Architectural Review Committee Meeting April 29, 2026

**4:00 p.m. Outback Steakhouse & Bonefish Grille Dual Restaurant (11114 S. State Street),
Jeff Jones (Owner), Craig Chaney (Merrick Lentz)**

Subject: Outback Steakhouse & Bonefish Grille Dual Restaurant
(Preliminary Site Plan Review) SPR02272026-007157

Subject: SEG Mall Redevelopment Ph 4B - Jazz Practice Facility SPR04222026-007197

EXTERIOR ELEVATIONS MATERIALS KEY (XXX)

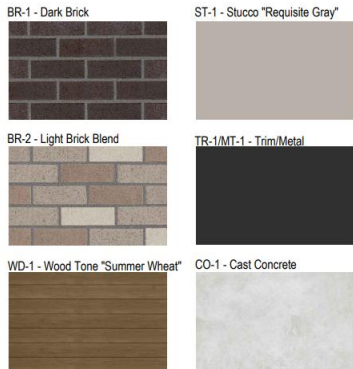
Staff Finding: The applicant is proposing four main materials and colors as mentioned above. Each color is earth toned and blend in well with the surrounding developments. Additional trim and cast concrete materials are also proposed which finishes enhance the main materials proposed.

Staff Finding: A trash enclosure is proposed on the rear (west facing) side of the building. The material shown appears to be a cinder block (CMU) material, but no defining colors have been included in the plan. Staff recommends that to maintain a consistent appearance to the structure that the trash enclosure material be the same brick material included on the building and not CMU as proposed.
